## **Addendum #2**

**Bid Opportunity: 7251-RW-22**

### **Waterloo Oxford District Secondary School - Family Studies Renovation & HVAC Upgrades**

1208 Snyder's Road West, Baden, ON N3A 4N2

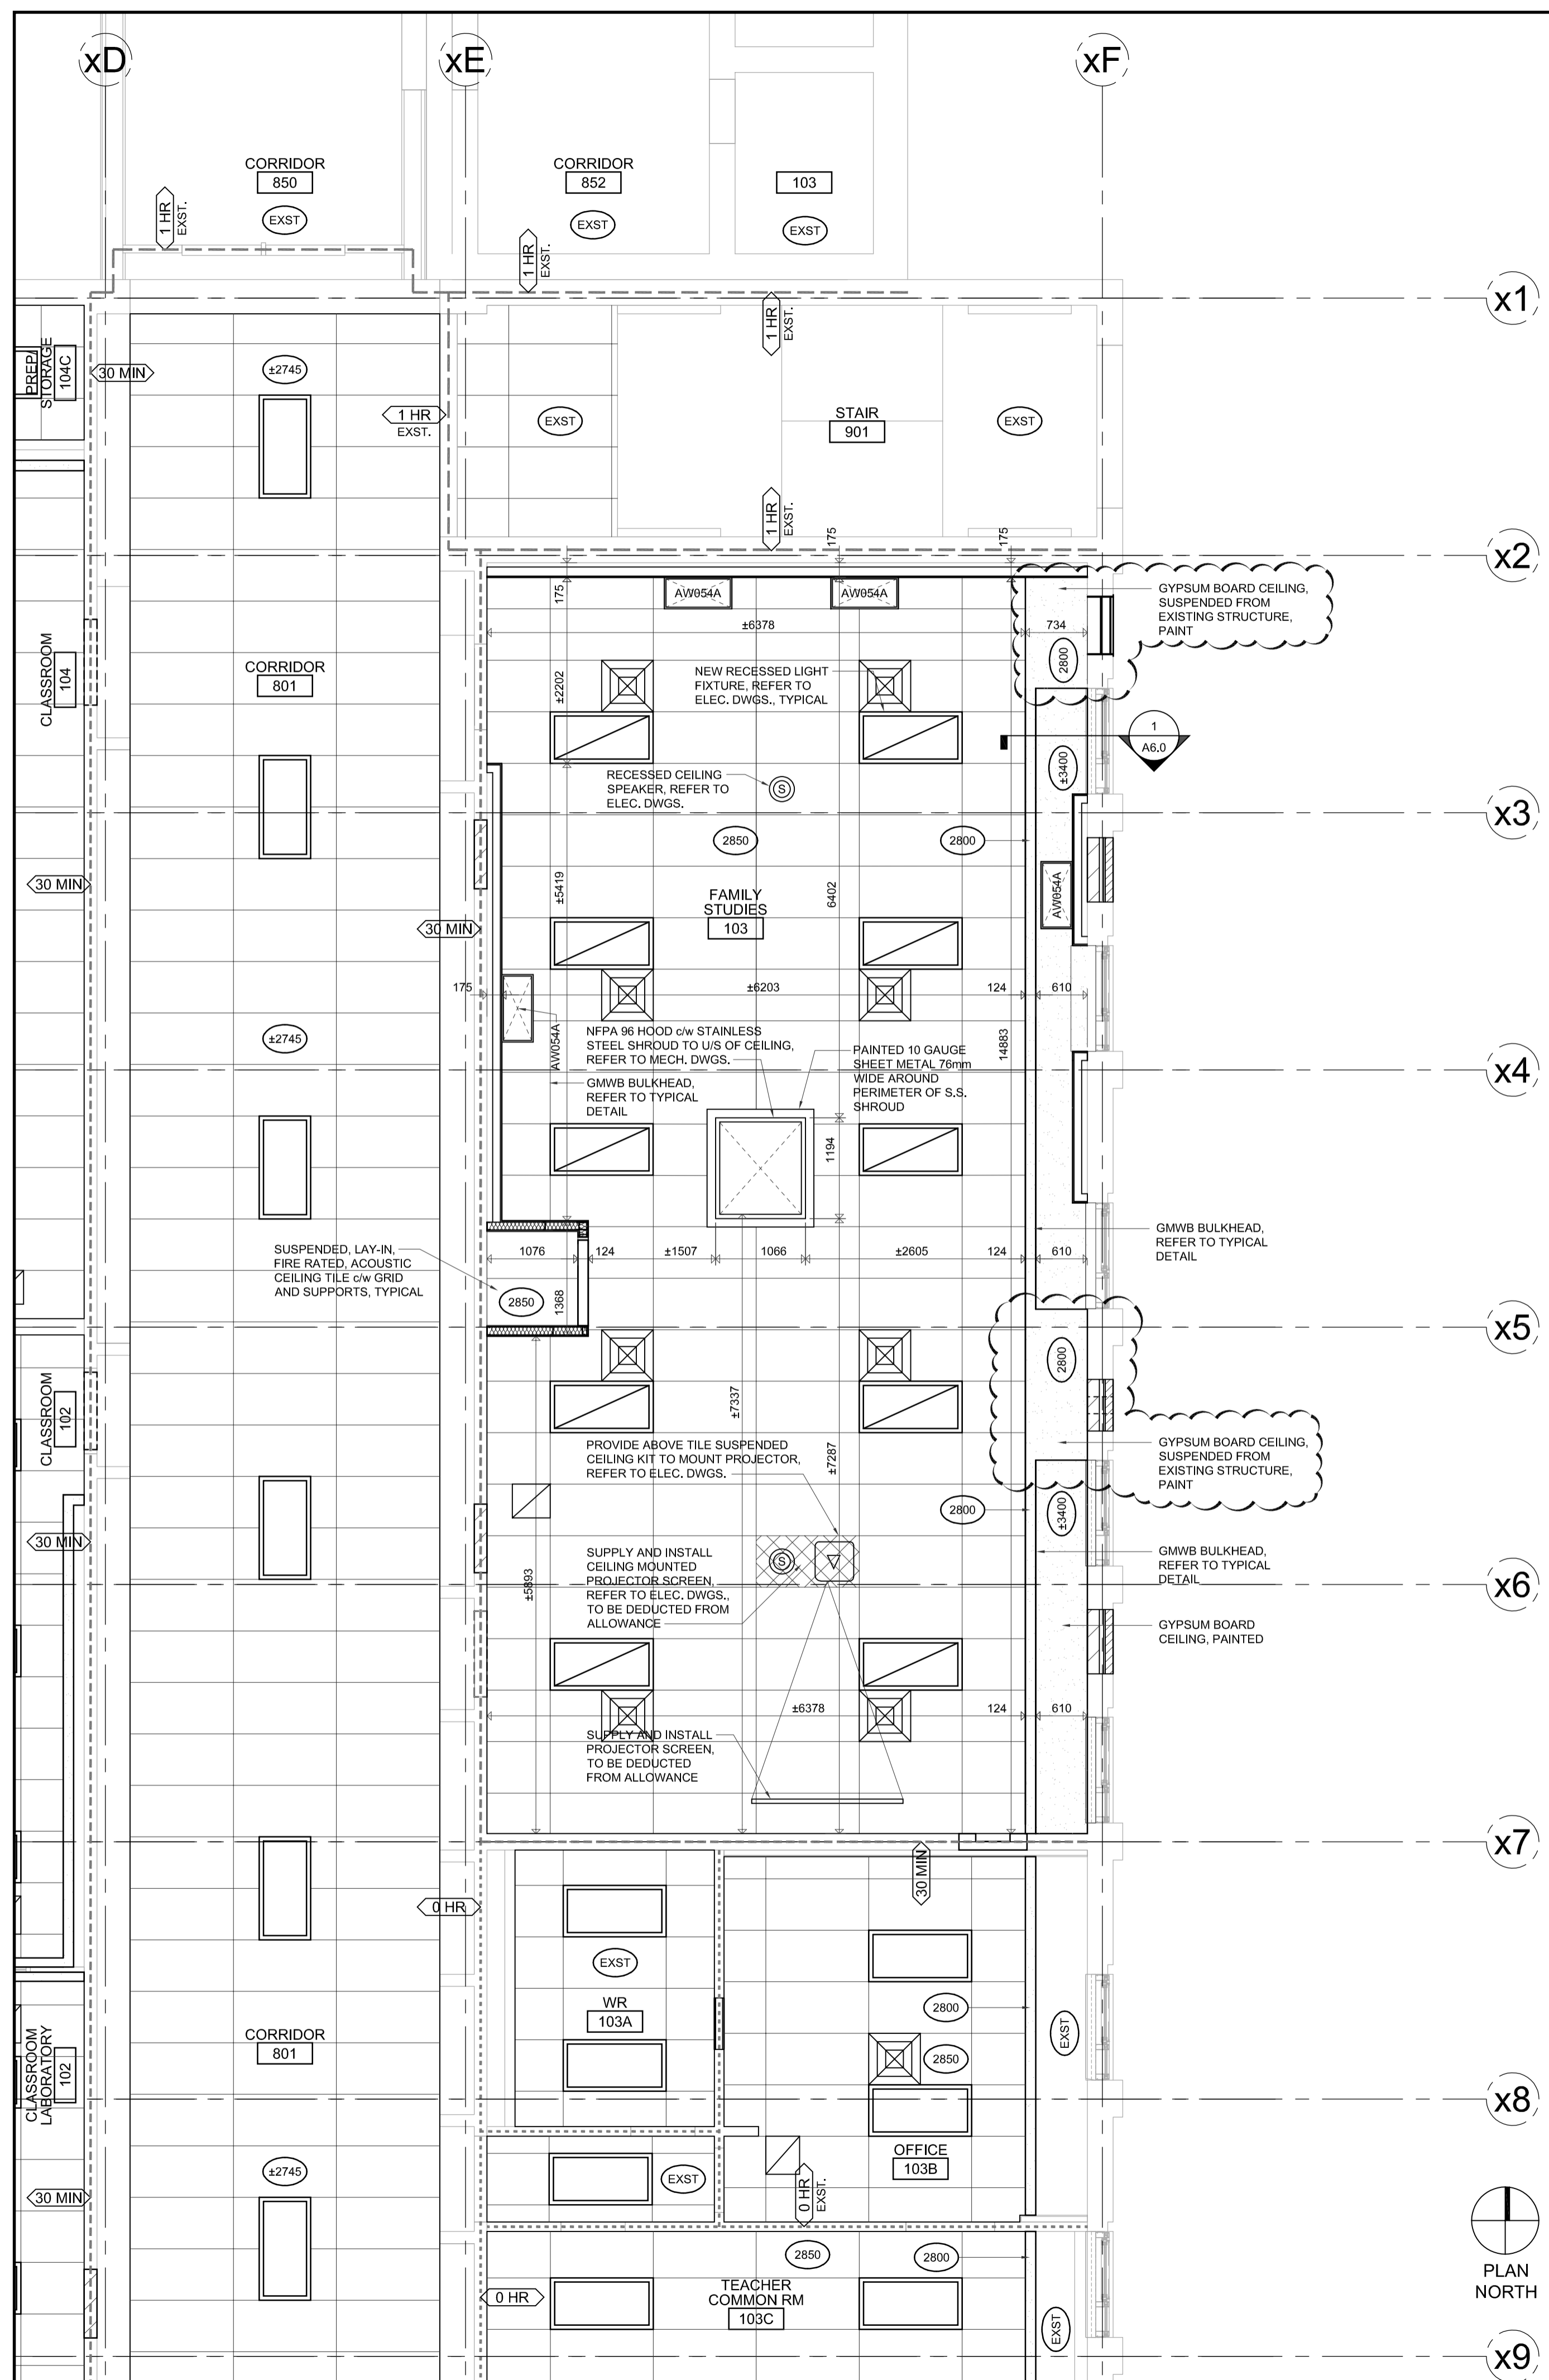
6. Drawing A3.2 Partial and Enlarged Reflected Ceiling Plans
  1. **REPLACE DRAWING A3.2 WITH DRAWING A3.2R, ATTACHED.**
    1. **1/A3.2 REVISED TO SHOW ADDITIONAL BULKHEADS.**

**ASK-001**

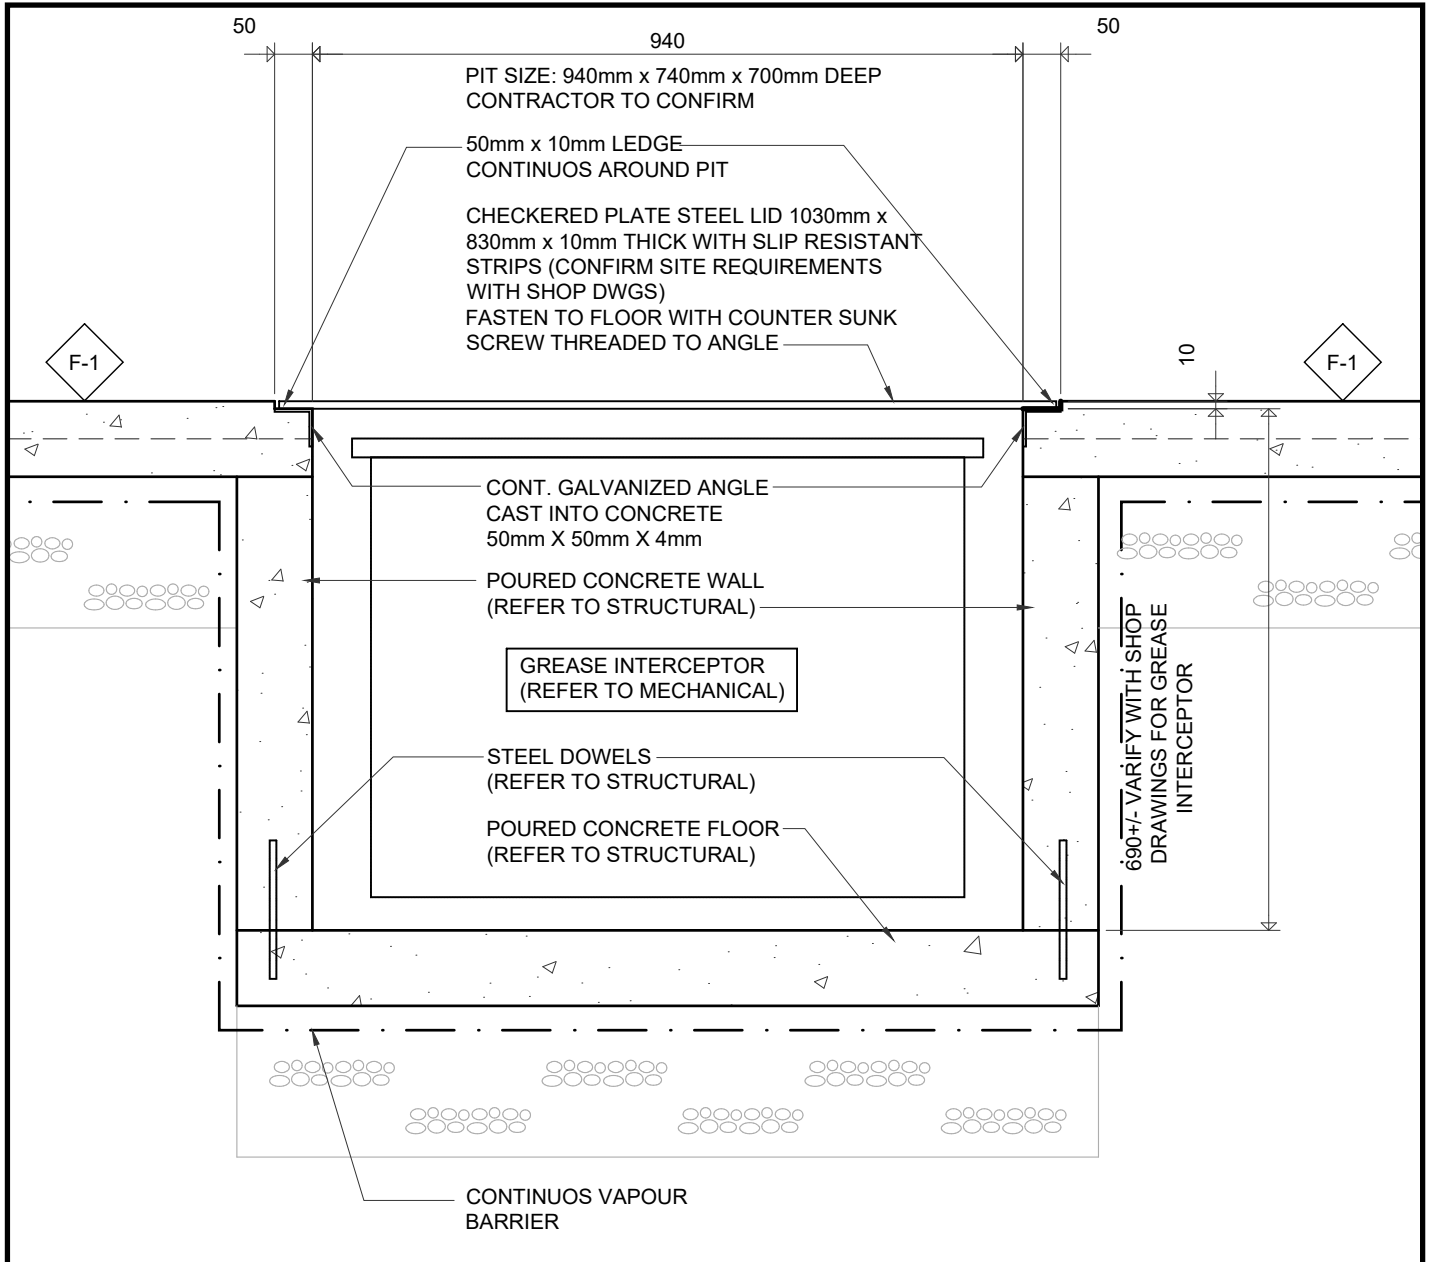
1. Drawing A0.0 OBC Matrix, General Notes, legends, Abbreviations, Drawing List
  1. **ADD DETAIL FOR GREASE INTERSEPTOR, AS SHOWN ON DRAWING ASK-001, ATTACHED.**
  2. **ADD FLOOR TYPE FOR INFILL OF SLAB-ON-GRADE, AS SHOWN ON DRAWING ASK-001, ATATCHED.**
2. Drawing A1.1 Partial Demolition Floor Plans
  1. **ENLARGED SECOND FLOOR DEMOLITION PLAN 2/A1.1 – PROVIDE OPENING FOR NEW LOUVRE AS SHOWN ON DRAWING ASK-002, ATTACHED.**
3. Drawing A1.2 Enlarged Demolition Plans & Partial Site Demolition Plan
  1. **REPLACE DRAWING A1.2 WITH DRAWING A1.2R, ATTACHED.**
    1. **1/A1.2 REVISED TO SHOW FLOOR CUTS REQUIRED FOR NEW SERVICES.**
    2. **1/A1.2 REVISED TO SHOW NEW OPENINGS FOR DUCTWORK.**

ASK-003

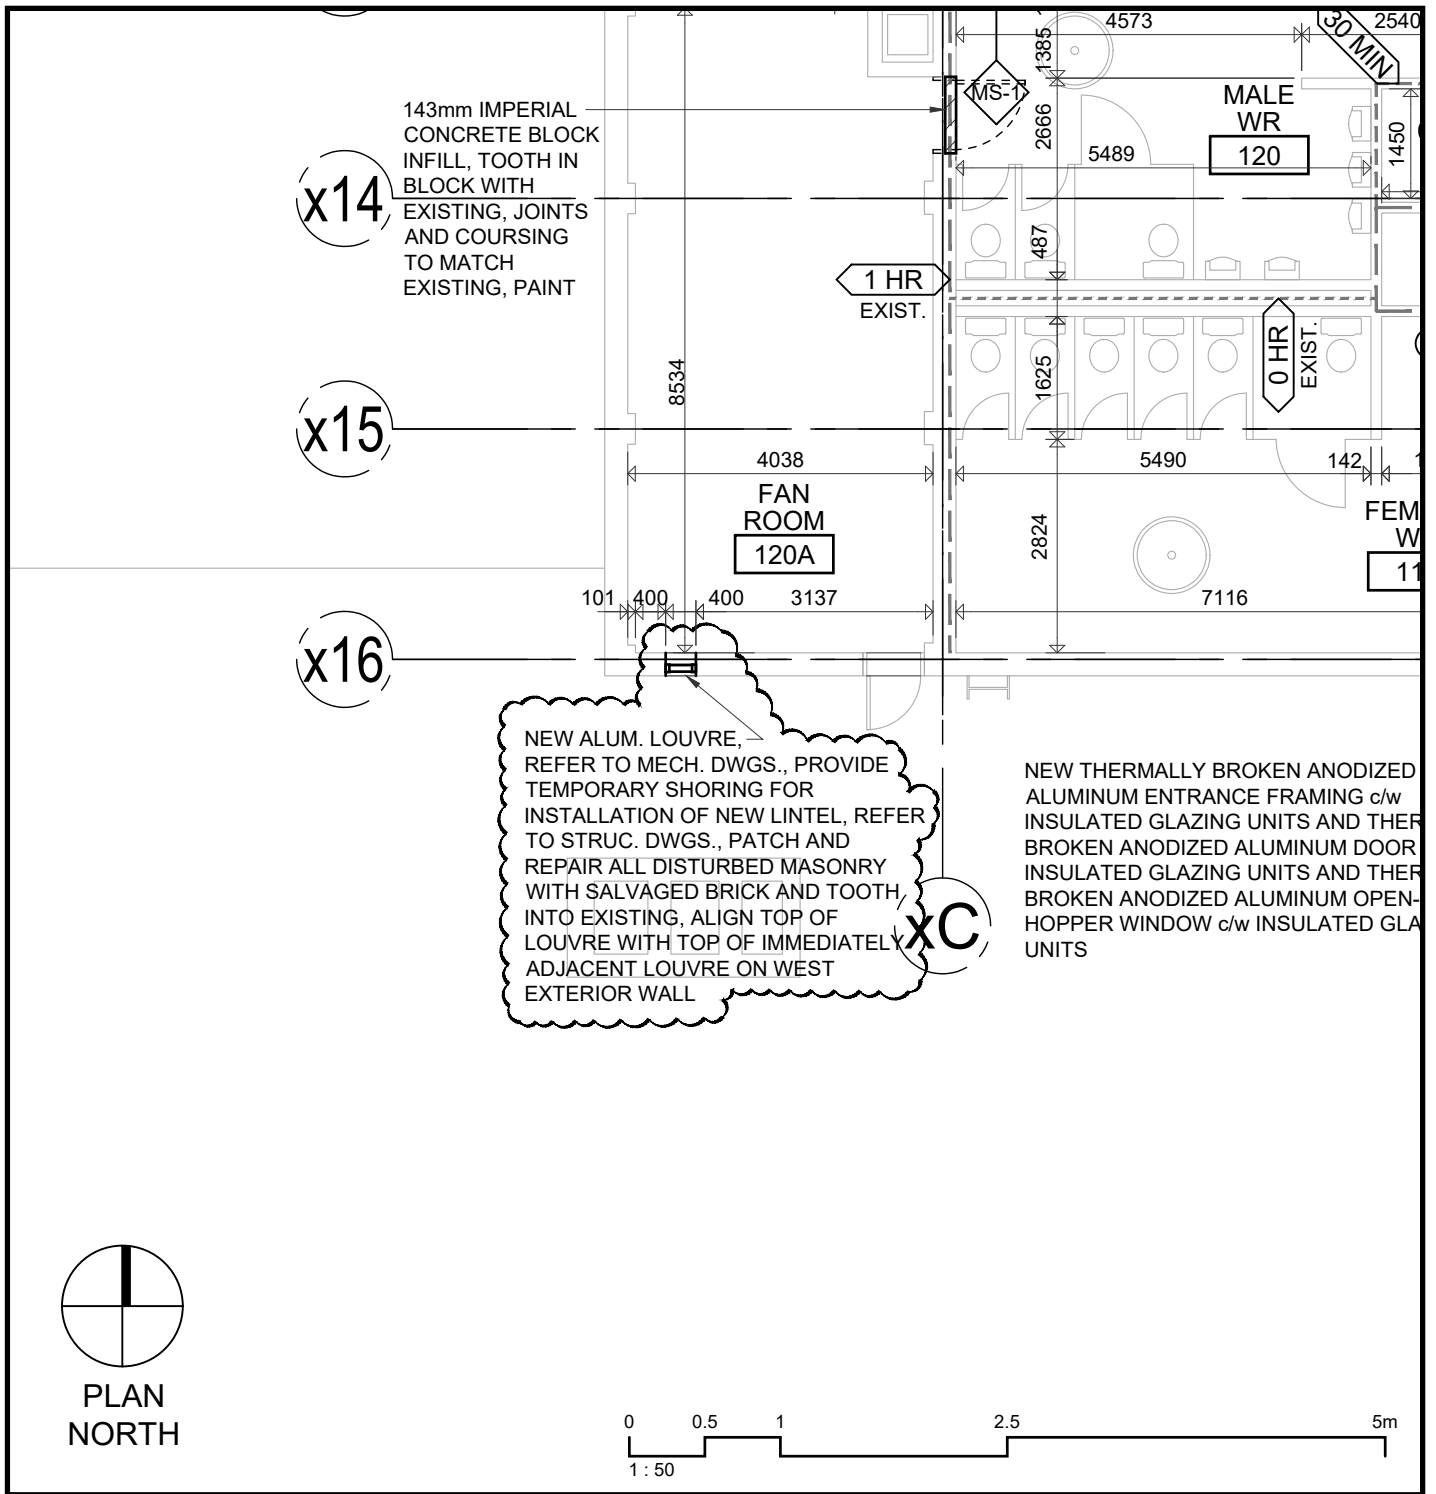
4. Drawing A2.1 Partial Floor Plans
  1. **PARTIAL SECOND FLOOR PLAN 2/A2.1 – ADD LOUVRE ON SOUTH WALL OF FAN ROOM 120A, AS SHOWN ON DRAWING ASK-003, ATTACHED.**

ASK-004

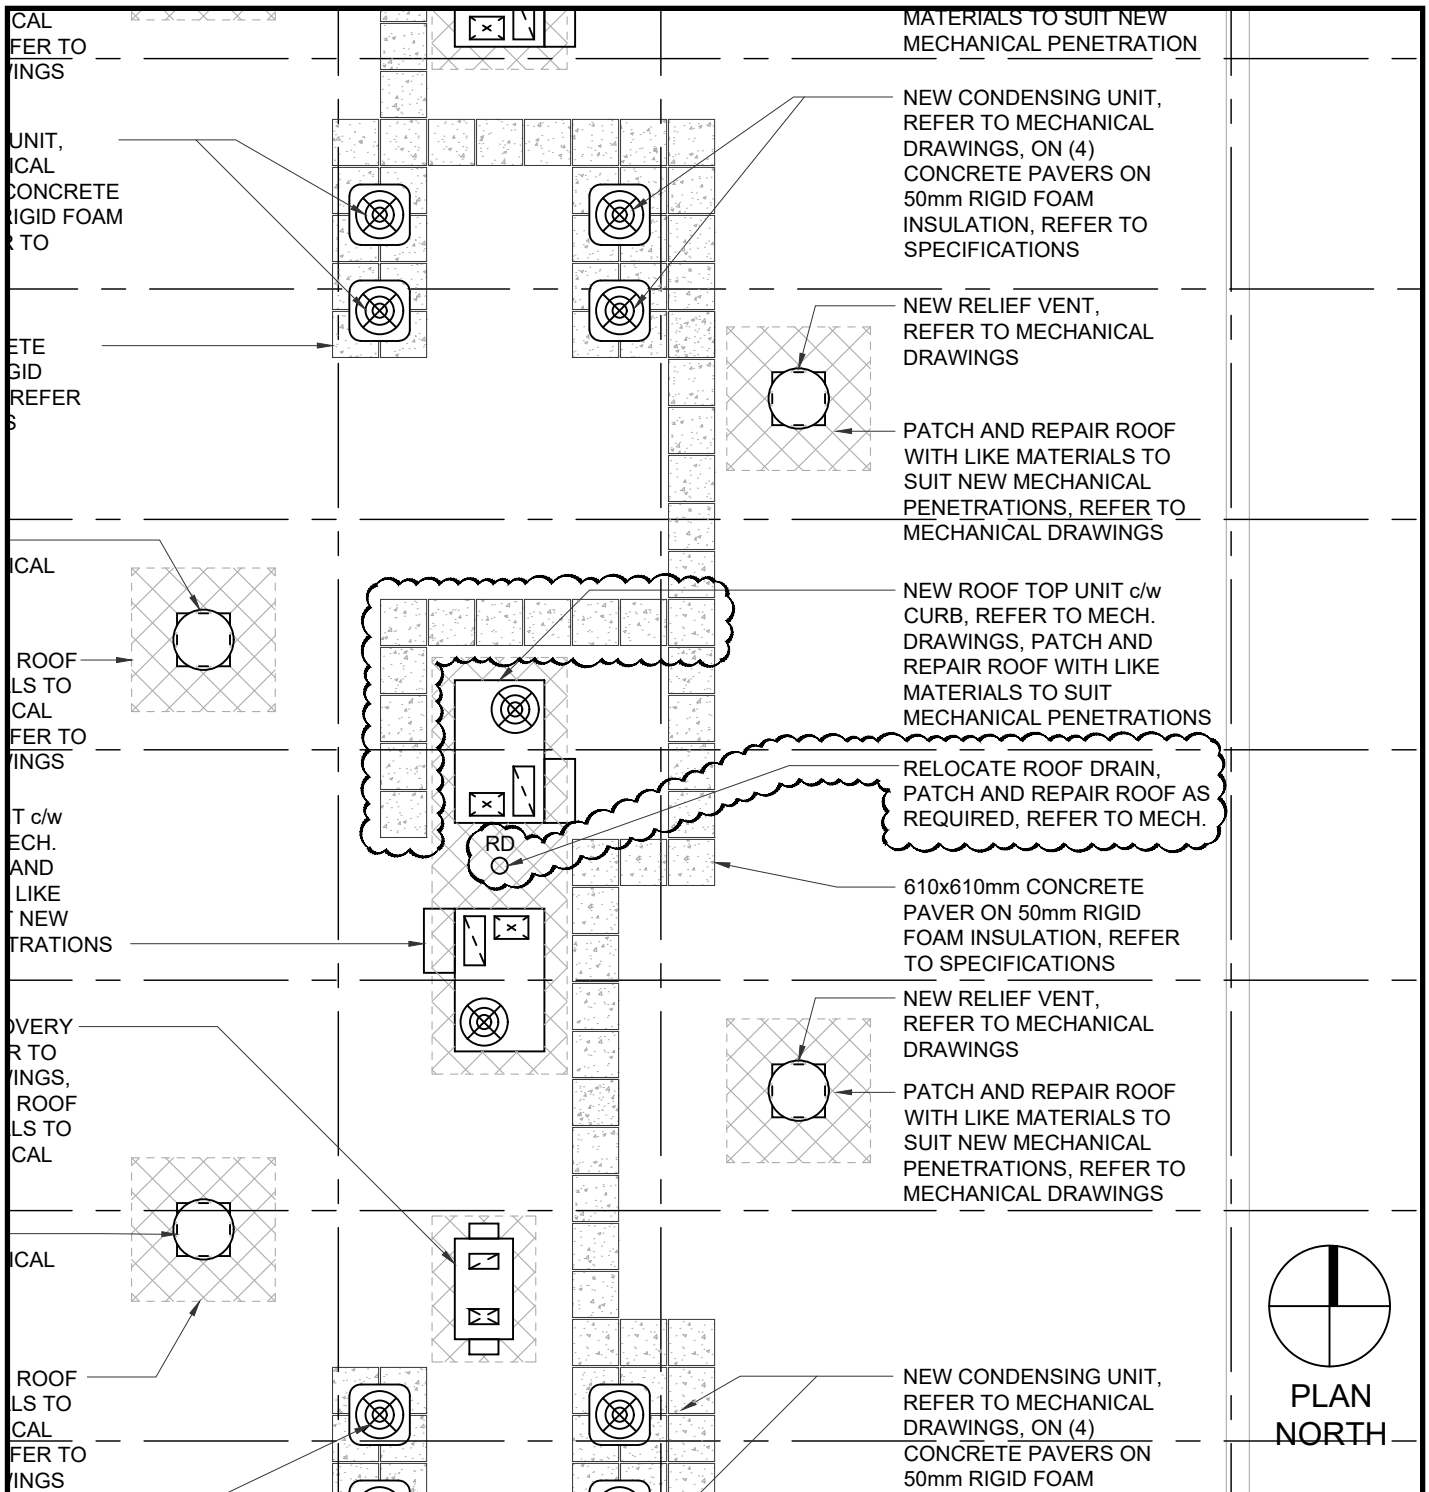
7. Drawing A4.0 Roof Key Plan & Partial Roof Plan
  1. **PARTIAL ROOF PLAN 2/A4.0**
    1. **RELOCATE ROOF DRAIN AS SHOWN ON DRAWING ASK-004, ATTACHED**
    2. **REVISE LAYOUT OF ROOF PAVERS, AS SHOWN ON DRAWING ASK-004, ATTACHED.**
